# COUNTY OF EL DORADO

**SUBJECT: Addendum No. 4  
Sawmill 1B Bike Path Project  
(Contract No. 95148)**

In addition to other changes, this Addendum No. 4 contains answers to the questions posed by potential bidders at the pre-bid meeting held on June 20, 2008.

RW-01A

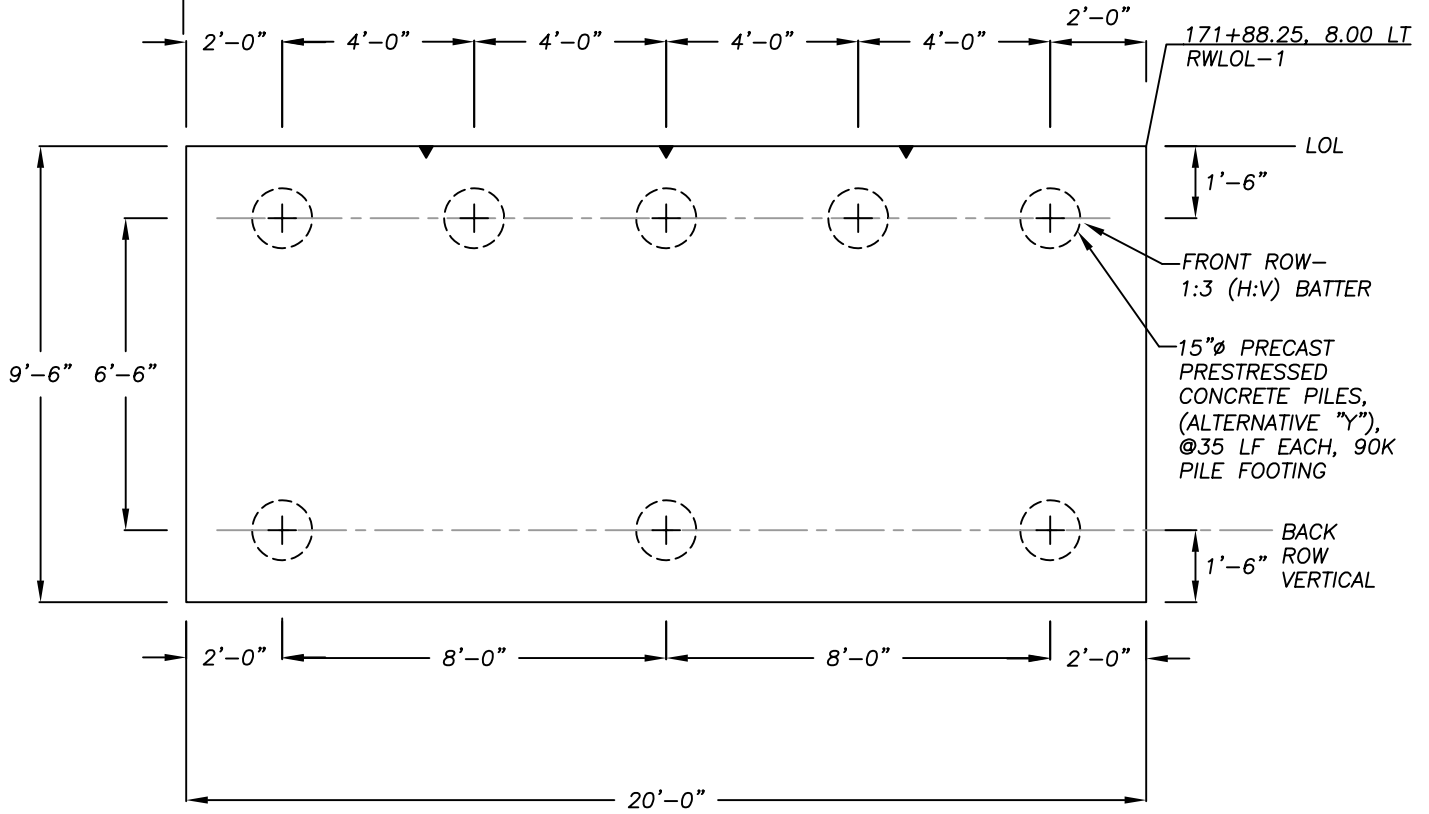
4.18	Special Provisions §10-1.00 (page SP-46, Bid Item 26)	<p>QUESTION: Are the retaining wall piles included in the Precast and Prestressed Concrete Pile bid item quantity?</p> <p>ANSWER: No. Precast and Prestressed Concrete Piles for the retaining wall shall be included in the unit price bid for the Concrete Retaining Wall – Type 5 bid item. Please see attached drawing for Retaining Wall Pile Layout which has been provided to satisfy Caltrans Standard Plan requirements related to Standard Plan Sheet B3-7.</p>

2. SEE STANDARD PLAN B2-5 FOR PRESTRESSED 15" CONCRETE PRECAST PILES, CLASS 90, ALTERNATIVE "Y"
